Agenda – Council – December 12, 2012

Item No. 3 Precinct Plan – Rosser, Old Kildonan bounded by Jefferson and CPR, Inkster Gardens Neighbourhood bounded by Jefferson Avenue, King Edward Street and CNR line – Waterford Green (Old Kildonan and Point Douglas Wards) File SP 2/2012

Title: Precinct C (Waterford Green) Plan, SP 02/2012

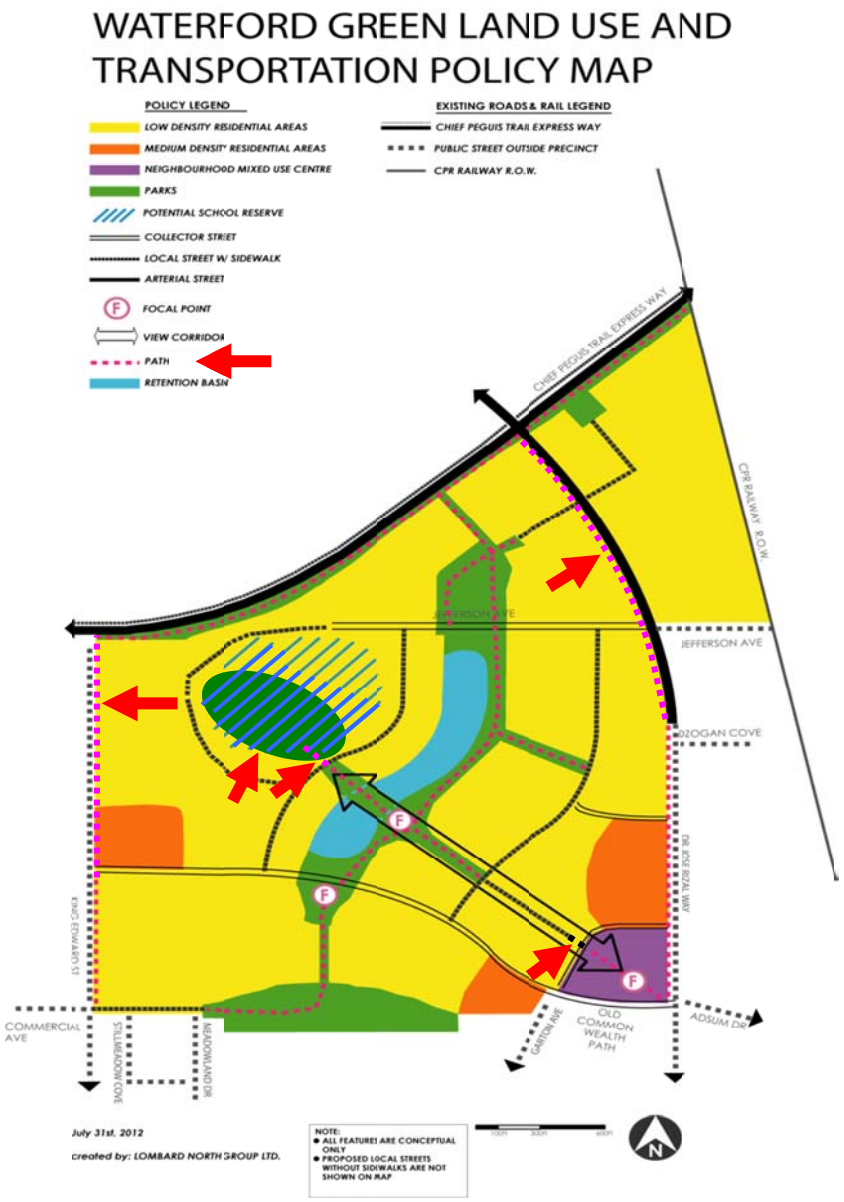
F. Replace the Waterford Green Land Use and Transportation Policy Map with the map in Attachment E – Amended Waterford Green Land Use and Transportation Policy Map, not including the red arrows which only identify the amendments to the map.

Note: Red arrows only identify amendments and should not be included in the approved Plan.
